SUBJECT: Forwards responses to Questions 361.20 through 361.25 in
 NRC 820426 letter re USGS draft status review. Thirteen oversize
 figures encl. Aperture cards are available in PDR.

Subject: NUCLEAR PROJECT NO. 2
RESPONSES TO NRC QUESTIONS CONTAINED
IN THE USGS DRAFT STATUS REVIEW

Q. 361.20

Q. 361.21

Figure
361.24-2

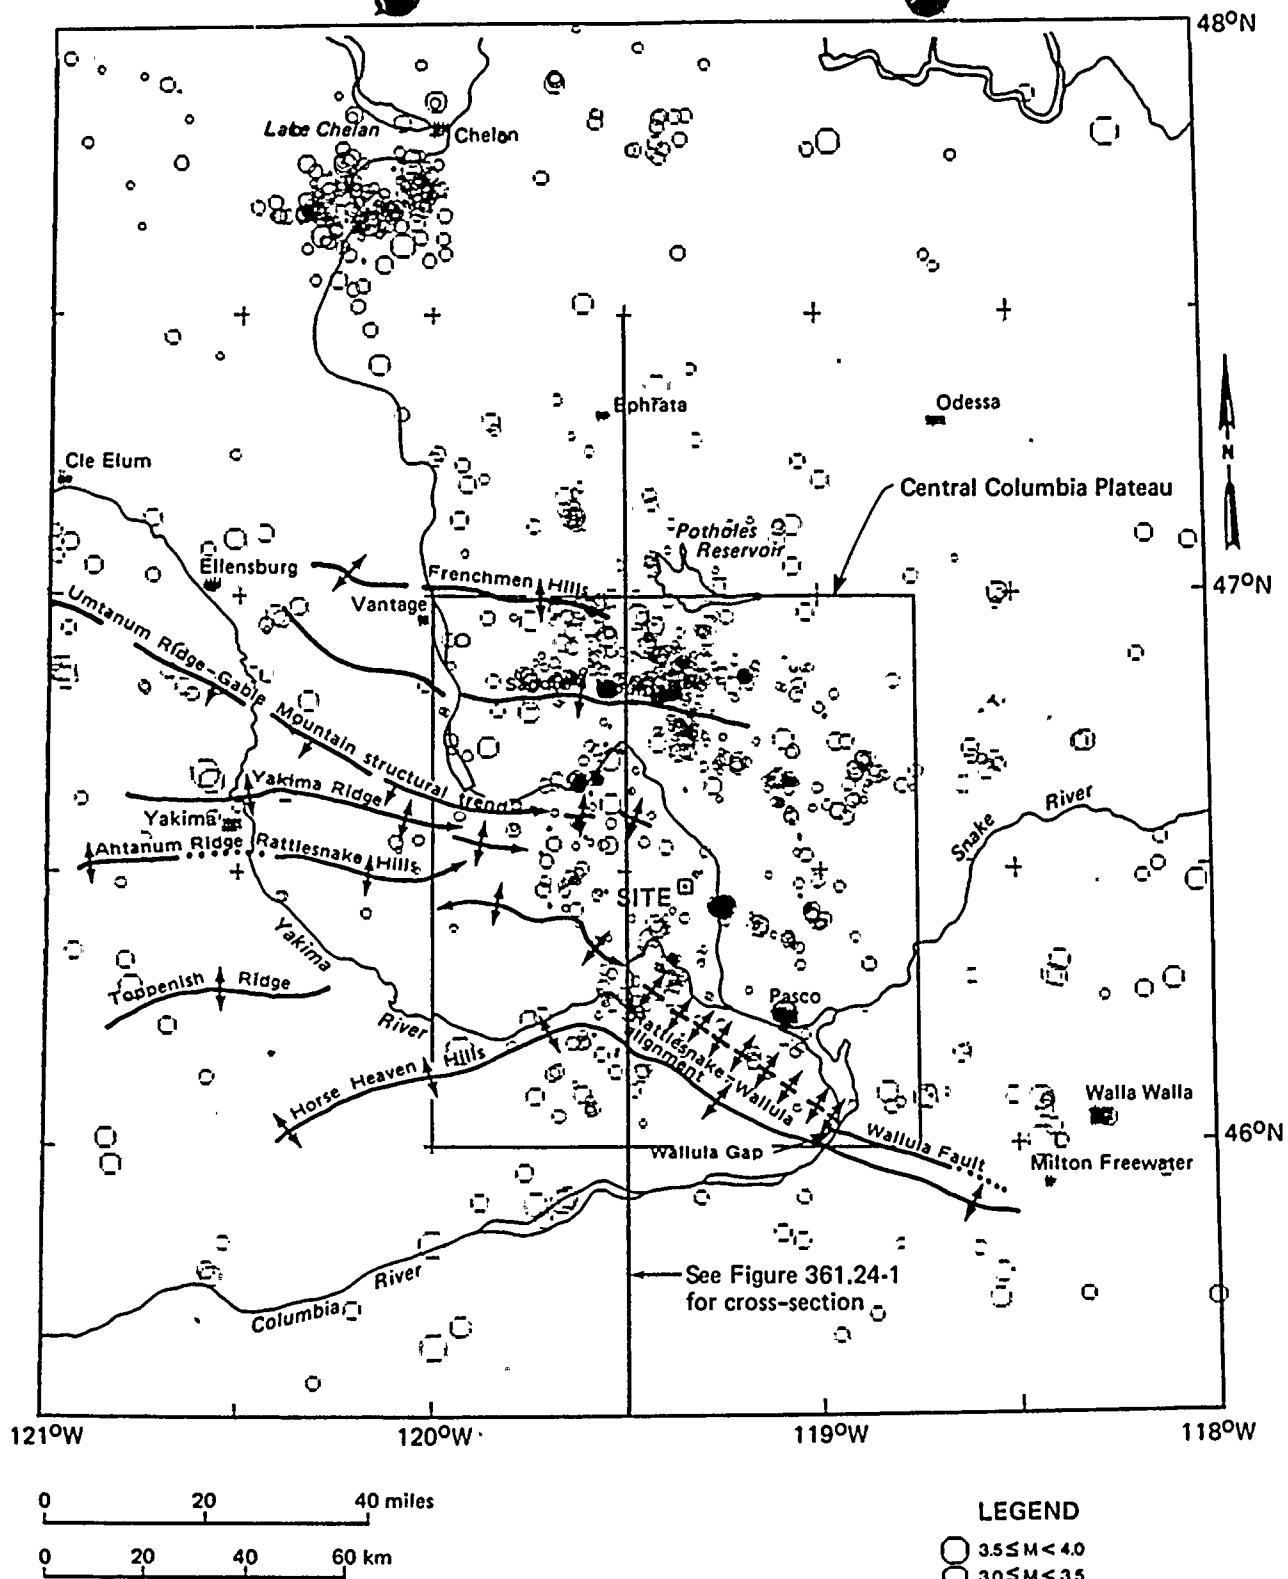
Illustrate explanation of the applicant's concept of "* * * intracrustal thrust-type detachments and less-throughgoing zones of interconnected faults and kink-bands." How do these relate to the "structural spectrum?" Where are they or where would they be expected? Show in schematic cross section(s) the conceptual and spatial relationships between the hypothetical faults and the crustal levels of Appendix 2.5 K (WPPSS, 1981), and the examples within the "structural spectrum" (3) above. Show the vertical zone through which the present-day north-south compression is acting. Show depths of significant earthquakes projected into cross section.

Figure 361.24-1 is a schematic cross-section that shows the postulated crustal levels and fault geometries discussed in Appendix 2.5K. These are superimposed on Columbia Plateau seismicity projected into a north-south line along 119° 30'W (Appendix 2.5J). The combined crustal structure and seismicity represent the vertical crustal section through which compression is operating. The line of cross section and an epicenter plot of the seismicity are shown in Figure 361.24-2.

Figure
361.20-2b

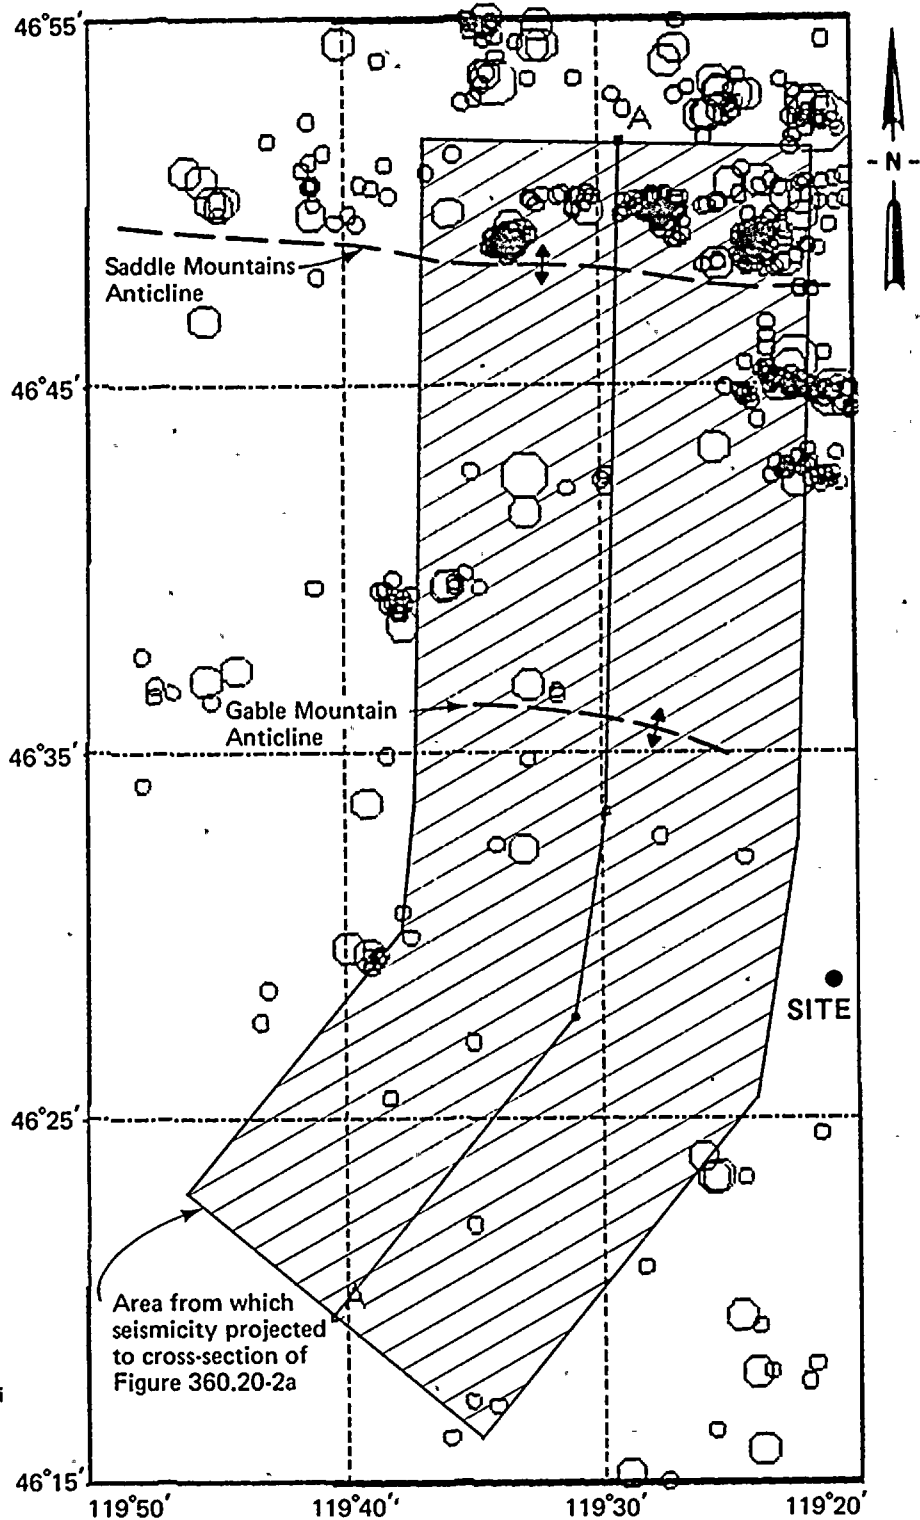
To-scale cross-section(s) of the geology through the site to a depth sufficient to include the elements critical to evaluation of the model.

The locations of cross-sections referred to in the responses to questions 361.20 to 361.25 are shown on Figure 361.20-1. A crustal geological cross-section through the site area extending from the south flank of the Frenchman Hills to the southwestern flank of Rattlesnake Mountain is shown as Figure 361.20-2a. This section, prepared at a scale of 1:62,500, incorporates: (1) surface geologic data; (2) two subsurface horizons based on magnetotelluric surveys (the base of resistive plateau basalts and possible pre-Columbia River basalt group volcanic rocks; the top of highly resistive crystalline basement (?) rocks; Myers and Price, 1979); and (3) the probable depth to basement rock based on Eaton's (1976) analysis of crustal structure using data from regional quarry blasts. Figure 361.20-2a extends to a depth of 20 km, 5 km above the seismically-inferred depth to the Moho beneath the Pasco Basin (Eaton, 1976; Hill, 1972, 1978)

Figure 361.20-2b also shows the location of earthquake hypocenters projected from zones 10 km wide on each side of the section (ie. 20 km total width). The seismicity shown includes all earthquakes above magnitude M_c 1.0, regardless of depth; all events having poor quality location (type D) and those events arbitrarily assigned a fixed 3.0 km hypocentral depth are excluded (WNP-2 FSAR Appendix 2.5J). The relationship between shallow crustal seismicity in the Plateau and individual geologic structure is discussed in WNP-2 FSAR, Appendix 2.5J.

Figure
361.23-1

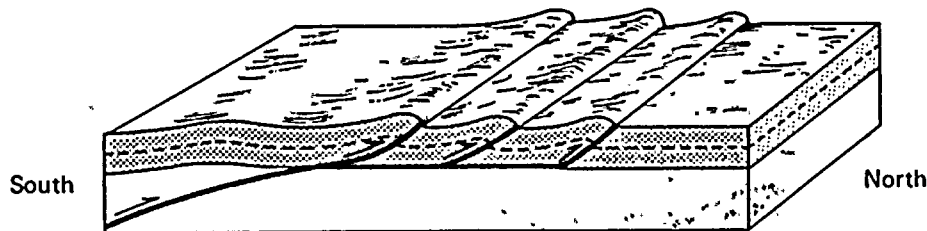
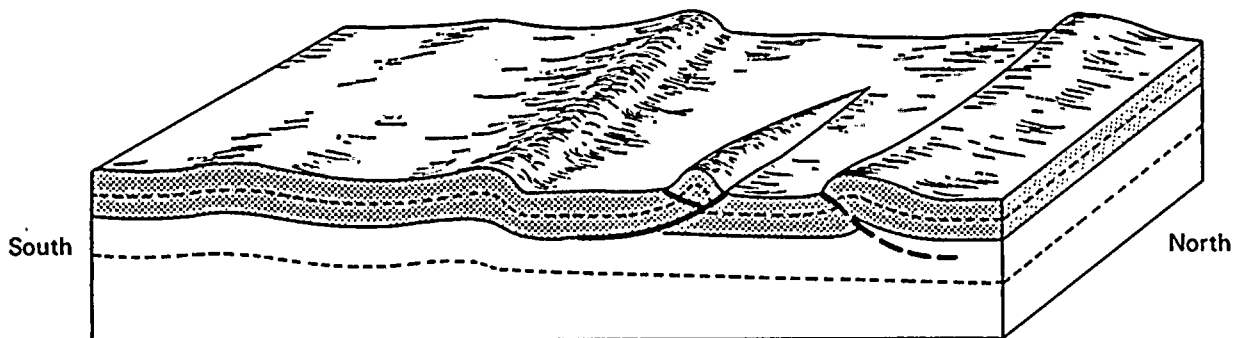
Well-illustrated explanations of the structural relationship between the RAW trend and the large folds (Gable Mountain, Saddle Mountains, and Frenchmen Hills) that extend far to the north and east of RAW. This explanation should include but not be limited to, adequate analysis of Price's (1981) model, Item 10 (2) of "Conclusions," which suggests many miles of northward translation of an originally east-west trending fold. How does this translation take place? What is the evidence for translation and what bearing does the translation represented by this and other folds have on structural interpretations below the WNP-2 site?

The two models discussed here are regional counterparts to the "structural spectrum" of fold/fault development originally applied to specific plateau folds. These models are: (I) the development of both Yakima-type structures and those of RAW as a consequence of intracrustal detachment with analogy to the incipient formation of a thrust and fold belt of foreland type (Figure 361.23-1A); (II) the development of Yakima-type structures in response to crustal buckling dynamics, treating the plateau as a layered medium and including geometrically-required detachments that develop as a consequence of buckling (Figure 361.23-1B). In model II the structures of RAW represent interference effects between a buckled and locally detached upper crustal level and a deeper zone of diffuse and limited dextral strain.

WASHINGTON PUBLIC POWER SUPPLY SYSTEM Nuclear Project No. 2	LOCATION MAP: STRUCTURAL PROFILES ON TOP OF THE WANAPUM BASALT ACROSS THE UMATANUM RIDGE, GABLE MOUNTAIN, SOUTHEAST ANTICLINE AND SADDLE MOUNTAINS STRUCTURAL TRENDS	Figure 361.21-5
---	--	--------------------

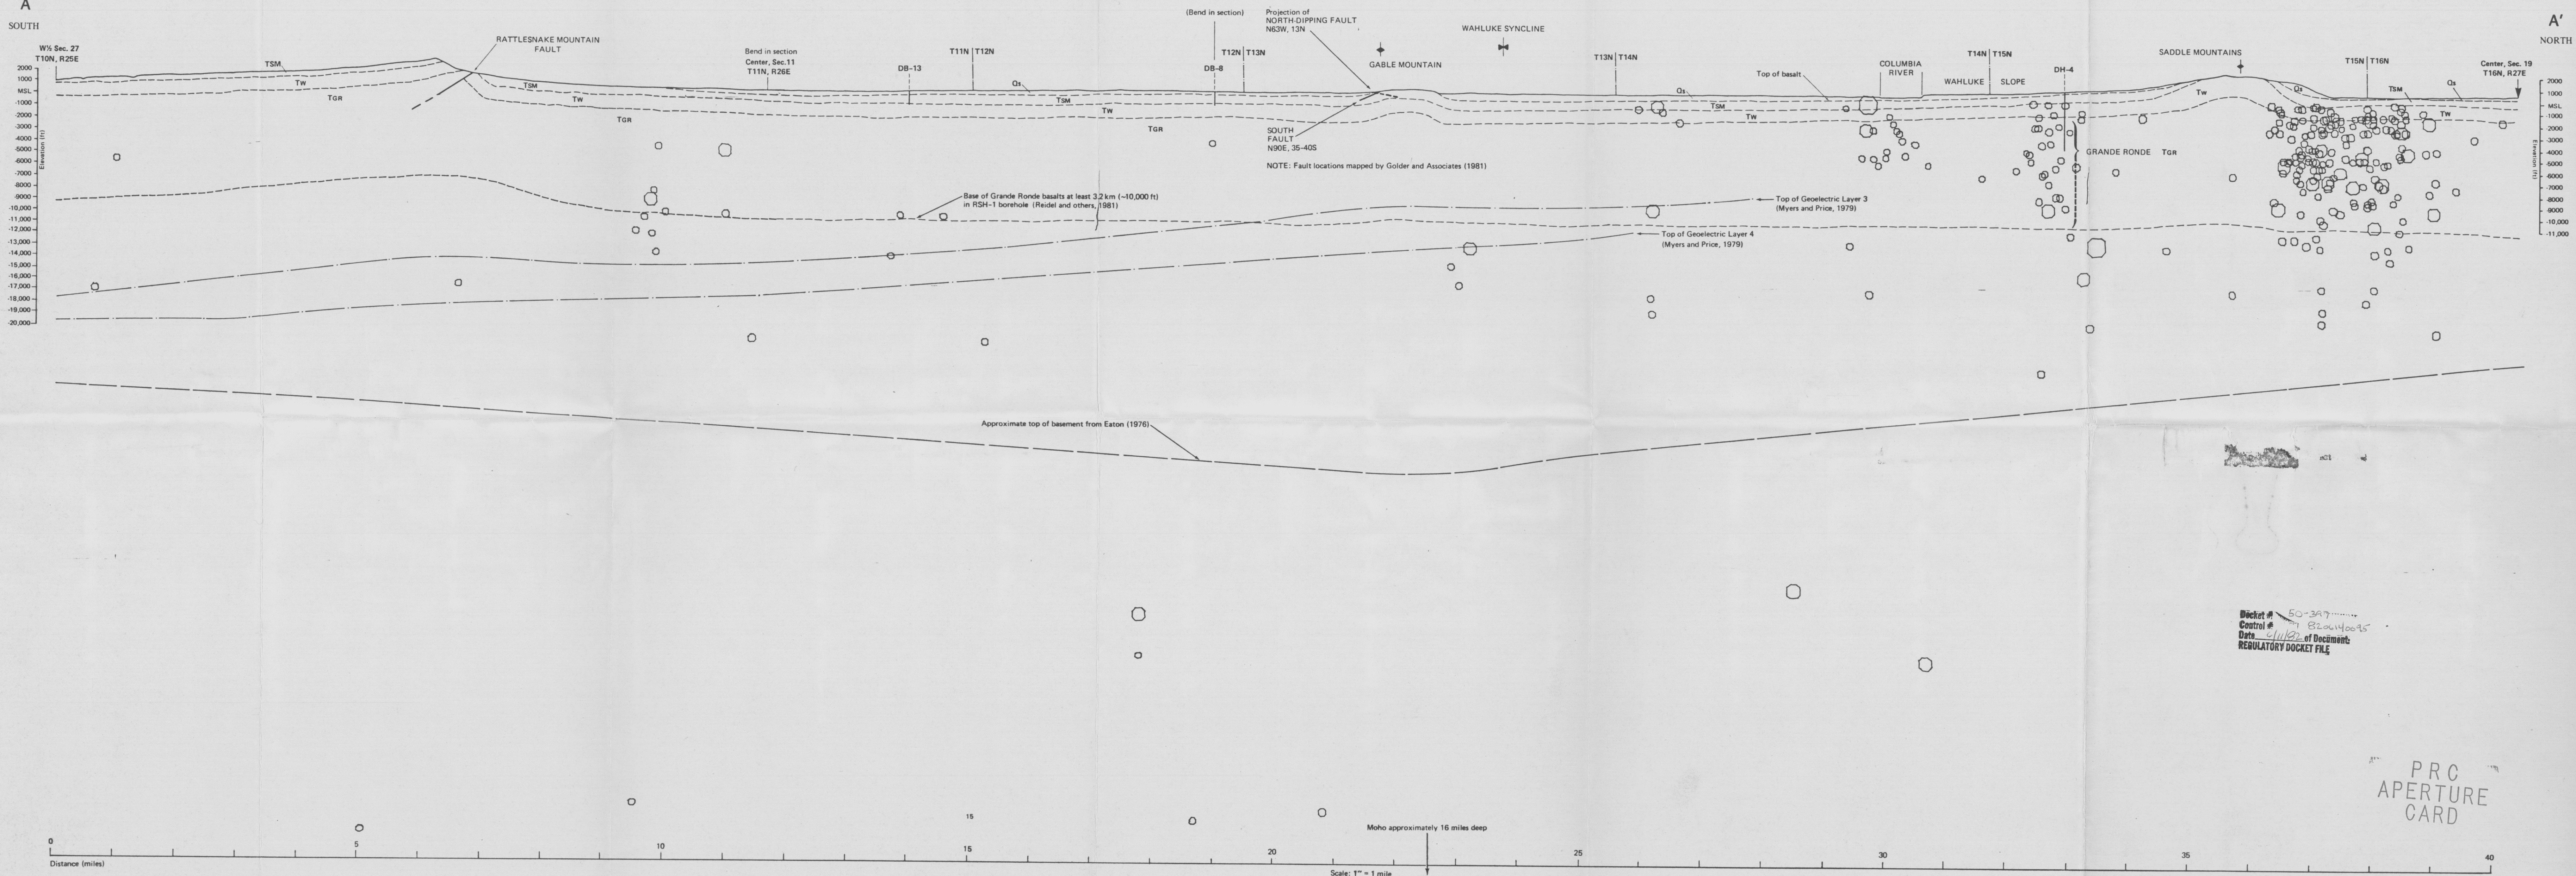
Provide comparison, with suitable cross sections, of the structural geology of the Umtanum-Gable Mountain-southeast anticline with Toppenish Ridge. Explain more fully what leads you to postulate a fault origin for Toppenish (WCC, 1981a) and a fold origin for Umtanum-Gable Ridge (Item 7, "Conclusions").

1979). The more detailed sections of Figure 361.21-5 have been drawn on the basis of surface mapping, borehole data, and two seismic reflection profiles across the western and eastern portions of Gable Mountain; data sources for the cross-sections are referenced on the figure. The three cross-sections through Gable Mountain (Figure 361.21-5 sections DD', EE', and FF') were prepared in response to question 361.25. Section DD' through the western half of Gable Mountain is of particular interest for several reasons: (1) it crosses the Gable Mountain anticline in its area of maximum structural relief (ca. 1250 feet on the top of Wanapum Basalt); (2) it crosses the structure where it exhibits its maximum horizontal components of shortening, approximately 925 feet (ca. 500 feet by flexuring between the axis of Wahluke syncline and borehole DC 1/2 and ca. 425 feet of heave on the "north-dipping reverse fault" projected into the line of section from the east); and (3) it crosses Gable Mountain where it most closely resembles the box-like geometry of Toppenish Ridge (Figure 361.23-2), although it verges southwards in contrast to the northward vergence of Toppenish.
